**Customer: PRINCETON PLASMA PHYSICS LAB**

Drawing ID: SE120-004

Nonconformance Report: Major Tool NC19562

This is for SE120-004 VVSA #2 end flange fit up and weld.

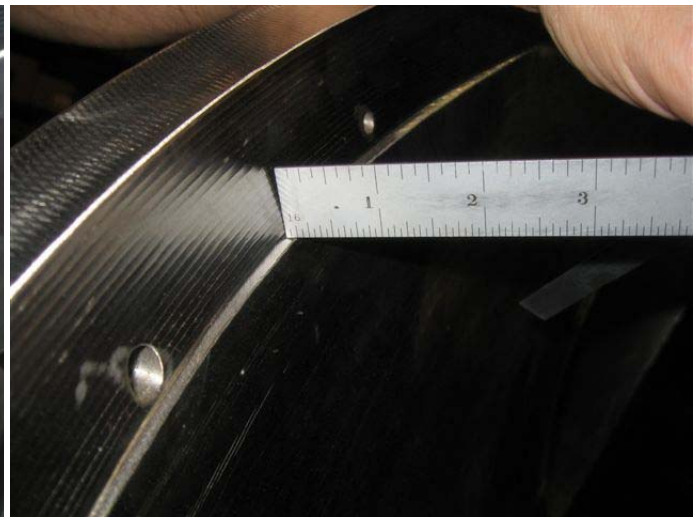
THE RESULT OF PROFILE DEVIATION ON THE VESSEL ENDS CAUSES A MIS-ALIGNMENT TO THE VESSEL FLANGES. REFER TO PHOTOS FOR ADDITIONAL DESCRIPTION.

RECOMMEND LEAVING THE VESSEL WALL IN ITS CURRENT POSITION AND ALTERING THE WELD SCHEME TO BLEND THE TWO SURFACES TOGETHER IF NO ASSEMBLY OR PLASMA INTERFERENCE EXIST

Rework as Recommended by MTM.  
Ensure weld size is equal or greater to original.
